Access Compliance Report

Public Rights-of-Way

(Curb Ramps)

Intersection ID: 47087	Main Street: MARVIN_RD	Cross Street: COVENTRY_COURT_LN	Location: SW
ADA ID: 9A749B82B9AB	Ramp Type: BlendTrans1	Initial Pass/Fail: Fail	Overall Compliance: No
Severity Score: 1.25			
Codes/Mitigation Info/Possible Solution		Field Measurements/Component Compliance

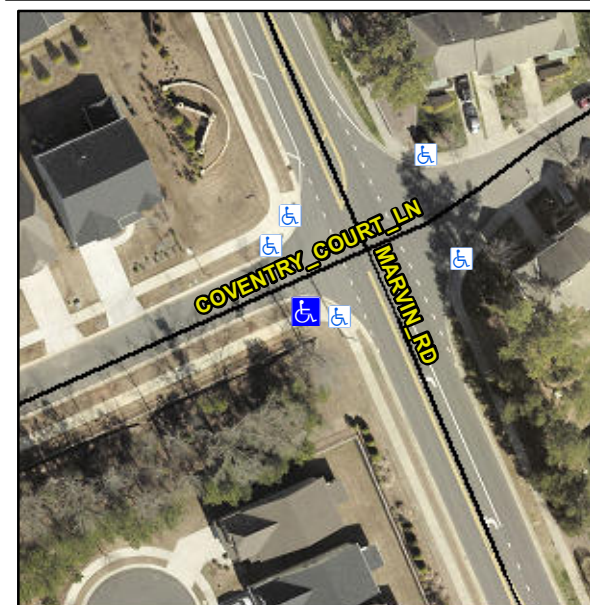
Not Found, R304.5.3

Compliance	Description	Data	Compliance	Description	Data
N/A	Ramp Length (in)	65.0	Yes	BlendTrans Slope (%)	4.0
Yes	Ramp Width (in)	61.0	No	BlendTrans XSlope (%)	3.1
N/A	Flare Type LT	N/A	N/A	Flare Type RT	N/A
N/A	Flare Slope LT (%)	N/A	N/A	Flare Slope RT (%)	N/A
N/A	Flare Traversable LT?	N/A	N/A	Flare Traversable RT?	N/A
N/A	Landing Length (in)	N/A	N/A	DWS Provided?	N/A
N/A	Landing Width (in)	N/A	N/A	DWS Contrast?	N/A
N/A	Landing Slope (%)	N/A	N/A	DWS Length (in)	N/A
N/A	Landing X Slope (%)	N/A	N/A	DWS Full Width?	N/A
N/A	Landing Curb? (Y/N)	N/A	N/A	DWS Offset (in)	N/A
N/A	Shared Landing?	N/A			
N/A	Gutter Ponding?	N/A	N/A	Gutter Slope (%)	N/A
N/A	Gutter Lip Ht (in)	N/A	N/A	Gutter X Slope (%)	N/A
N/A	Painted X Walk1?	No	N/A	Painted X Walk2?	N/A
	X Walk 1 Direction	To NW		X Walk 2 Direction	N/A
	X Walk 1 Width (in)	N/A		X Walk 2 Width (in)	N/A
	X Walk 1 Slope (%)	7.0		X Walk 2 Slope (%)	N/A
	X Walk 1 X Slope (%)	2.9		X Walk 2 X Slope (%)	N/A

N/A	Ramp inside XWalk1?	N/A	N/A	Ramp inside XWalk2?	N/A
	Road Slope (%)	2.9		Clear Space?	N/A
	Road X Slope (%)	7.0	N/A	Clear Space to XWalk (in)	N/A
N/A	Any Obstructions?	N/A	N/A	Storm Grate/Utility Hazard?	N/A
	Obstruction Type			Storm Grate/Utility Type	
		N/A			N/A
			Yes	Surface Condition? (G/P)	Good
			No	Curb Slope (%)	6.0

Remove & Replace Curb Ramp With Two New Directional Ramps or Equivalent.
